# Loss from TP0 to TP2

P802.3ck Draft 3.1 comments 41, 43

Piers Dawe, Nvidia

April 2022

# TP0-TP2 with range of max-loss host channels and current mated test fixtures

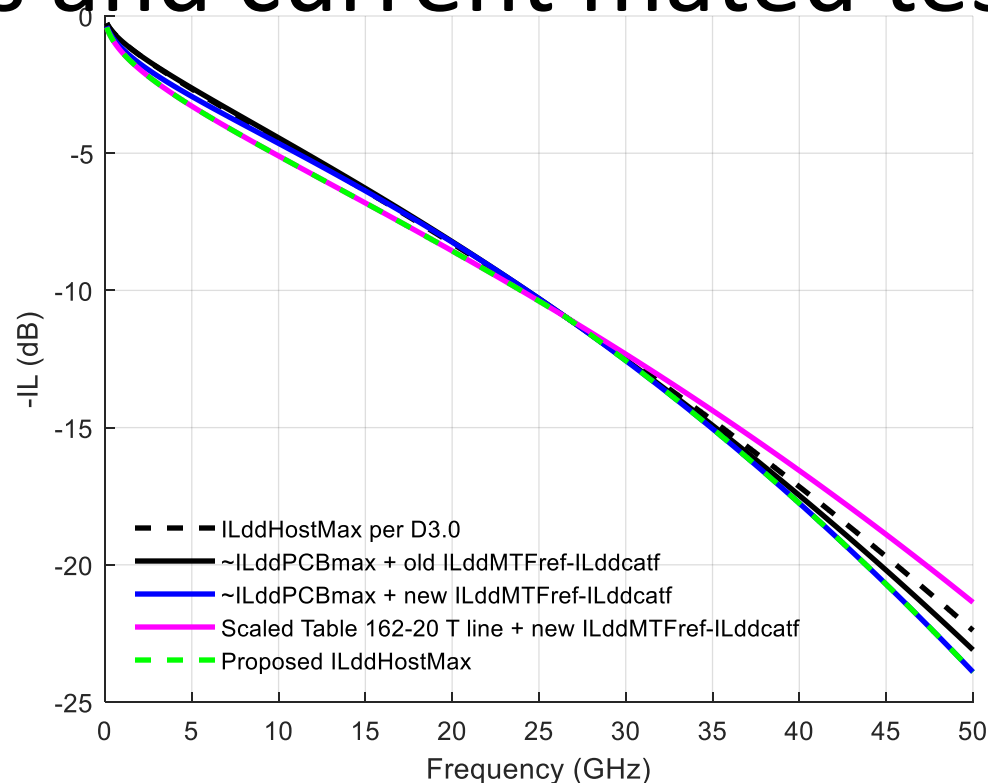
- Need to allow more curvature at low frequencies, but also roll-off well above Nyquist
- Recommend the magenta line below Nyquist and the blue above
  - A channel that rolls off more strongly than blue above ~35 GHz would work too
- Combination is shown as dashed green

- Figure 162A–2 Insertion loss from TP0 to TP2 or from TP3 to TP5

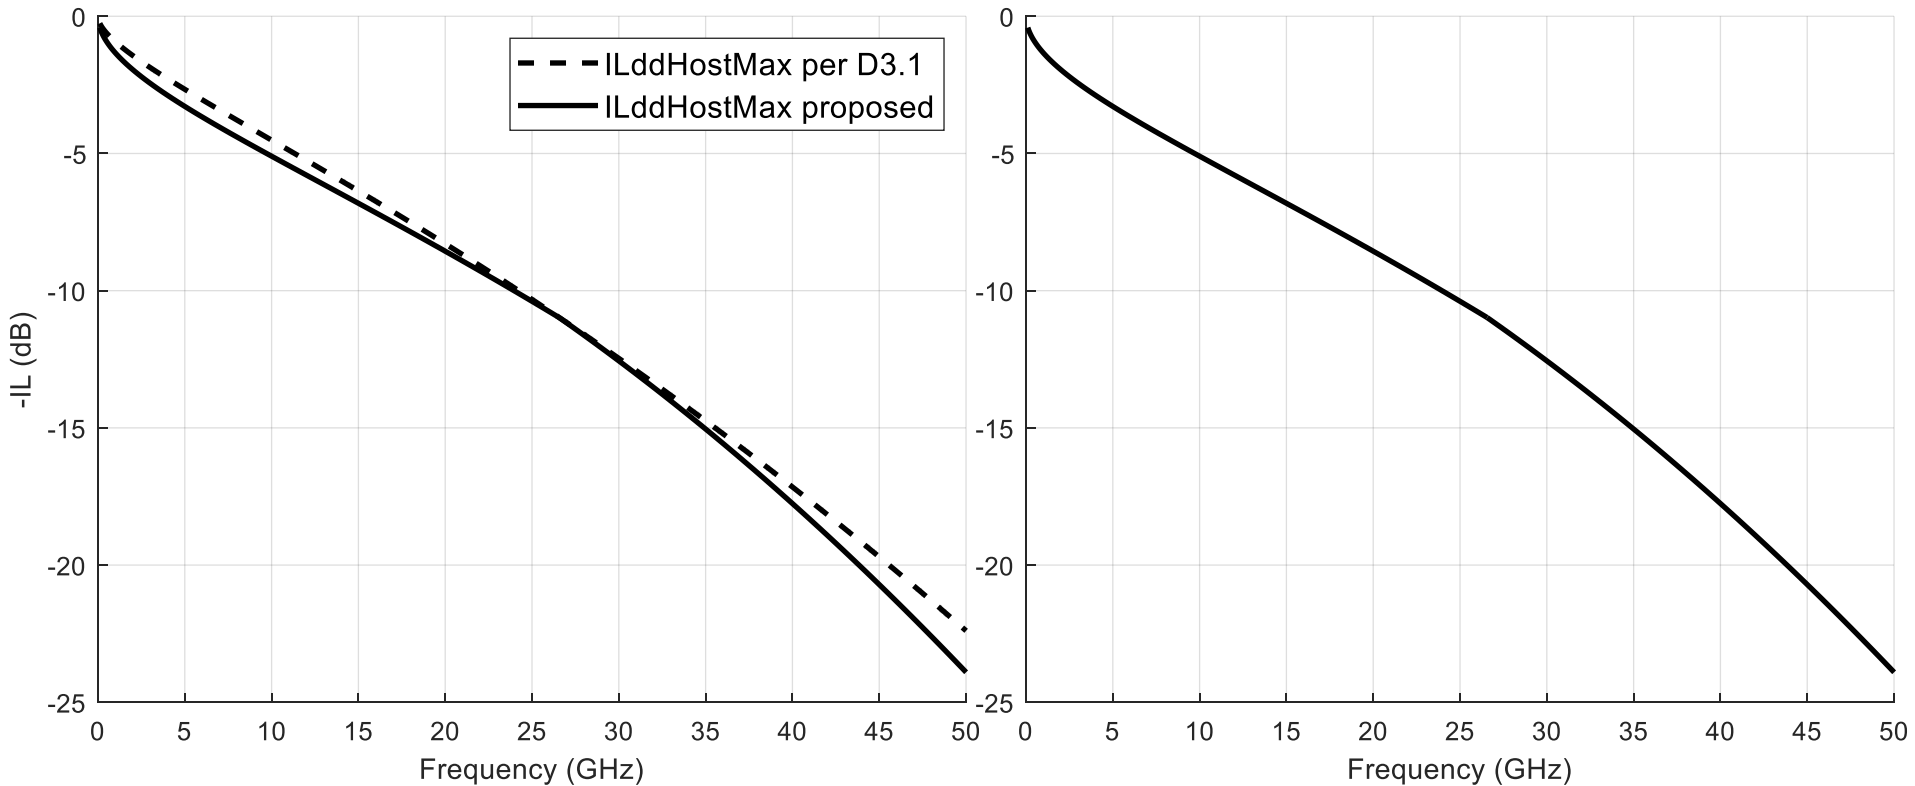
# Summary, new plot for Fig 162A–2

- Equation 162A–3
  - Existing:  $ILdd_{Host} \leq ILdd_{HostMax} =$   
 $1.5658*(0.471*\sqrt{f}) + 0.1194f + 0.002f^2$
  - Proposed:  $ILdd_{Host} \leq ILdd_{HostMax} =$   
 $1.2513*\sqrt{f} + 0.08007f + 0.003405f^2 \quad 0.01 \leq f \leq 26.56$   
 $1.1351*\sqrt{f} + 0.05202f + 0.005310f^2 \quad 26.56 < f \leq 50$
- Recalculate *Rpeak* (min) based on the magenta line
  - Table 162-10
  - ISI affects *Rpeak* too, so can't use the smooth curves: have to go back to more realistic models with ISI
  - Existing: 0.397
  - Proposed: **TBD**
